# Mixed-Signal Control Processor with ARM Cortex-M4/M0 and 16-Bit ADCs

## Silicon Anomaly List

## ADSP-CM411F/412F/413F/416F/417F/418F/419F

**19. 17000064 - Back-to-back Writes to Internal SRAM May Be Lost:****DESCRIPTION:**

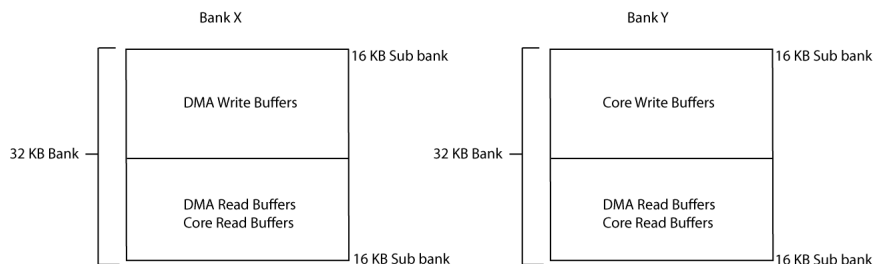
When back-to-back writes are performed to the same 32 KB bank of the internal SRAM, the first write may be lost if address bit 14 is different (all other bits are the same) on the second write.

The figure shows an example where address bit 14 is different for two accesses.

The following workarounds utilize memory placement strategies, where two consecutive write addresses are not 16 KB apart.

The figure shows the memory placement when DMA write buffers are between 16 KB and 32 KB.

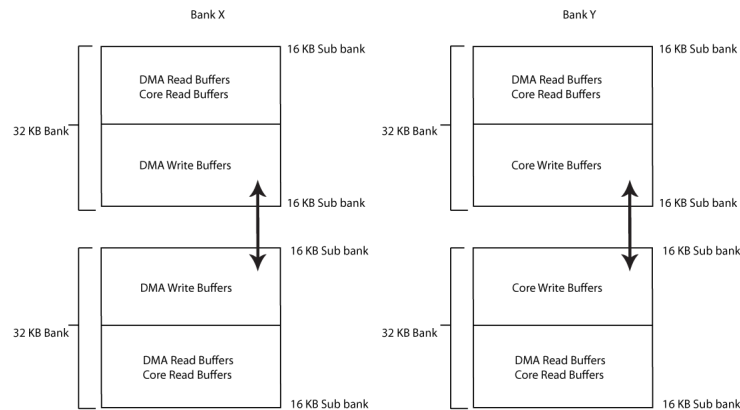
2. If DMA requires more than 16 KB but less than 32 KB for writes, and DMA writes are a single linear stream, the workaround is to place the write data buffer in a single bank that has data in both halves of the bank. This issue does not exist in case of a linear addressed DMA. If DMA writes are not sequential and ordered and the DMA buffer requires more than 16 KB, the region must start from the higher half of the bank and continue into the lower half of the next bank. Core-writable variables may be placed in the other half of the 32 KB bank that contains read-only DMA regions.
